IAEA INTERNATIONAL PEER REVIEW MISSION ON MID-AND-LONG-TERM ROADMAP TOWARDS THE DECOMMISSIONING OF TEPCO'S FUKUSHIMA DAIICHI NUCLEAR POWER STATION UNITS 1-4

**Tokyo and Fukushima Prefecture, Japan
15–22 April 2013**

REPORT TO
THE GOVERNMENT OF JAPAN

Fig. 1. Waste management planning methodology

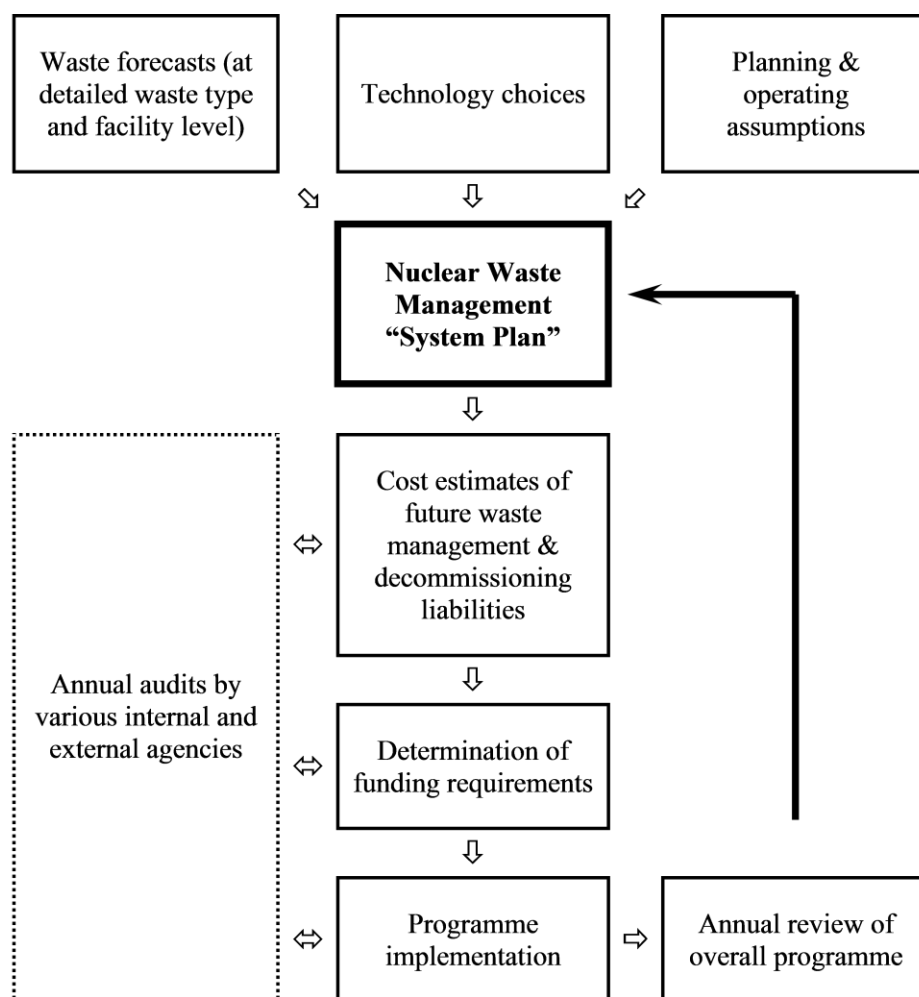
The execution of efficient waste management means full understanding of the task or more detailed knowledge of waste inventory tracking, forecasting and planning. The regular updates of inventory are required for all of current and future radioactive waste and spent fuel and fuel debris management options. Such updates are used to estimate and confirm the adequacy of funds required to pay for these future liabilities as well as to plan for future waste management needs. The overall methodology that could be used is illustrated with Fig.1.

The assessment should take into account all waste types and include lifecycle management needs from generation (clean-up) through transportation, treatment, storage and disposal. Waste forecasts should be done on the basis of individual waste type and/or facility. Various scenarios should be analysed, for example of alternatives to be pursued during different phases of the *Roadmap*. The stage-wise reference plan for waste management could be developed based on the results of these scenarios.

The IAEA team encourages TEPCO to start preparing its strategy and long-term waste management plan by estimating volumes, types and characteristics of different waste streams and by identifying optimized waste management scenarios for all phases identified by the Roadmap for decommissioning Fukushima Daiichi NPS, even though end-points for waste are not yet defined.
